COWICHAN VALLEY REGIONAL DISTRICT ENGINEERING SERVICES

ADDENDUM NUMBER 2

REQUEST FOR PROPOSALS ES-020-17 CVRD CONDITION ASSESSMENTS April 26, 2017

Regarding Underwater Inspection of the Mill Bay Small Craft Dock

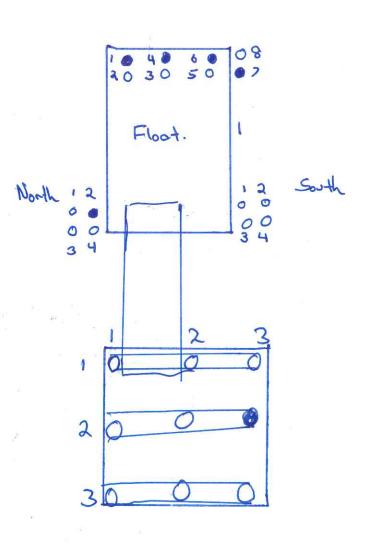
On June 16th 2014 Westcoast Diving Contractors Ltd conducted an underwater survey of the above mentioned dock facility. We recorded the dive with digital video and found some of the pilings completely rotten. We have listed the pilings below.

Pile 1 Rotten piling 0142 on DVD Pile 4 Rotten piling 0410 Pile 6 Rotten Piling 0630 Pile 7 Rotten piling 0740

North group Piling 2 Rotten Piling 1508

Row 2 piling 3 Holes in piling when probed and the pile is hollow in the center 4ft from bottom. 2800 on DVD

Some of the decking on the approach could use more nails to tighten up the boards. We also hammered the one bolt on the ramp hinge and we were able to move it. The threads were striped so we could not tighten it up. I hope we have answered your questions and if you have any more please call any time.
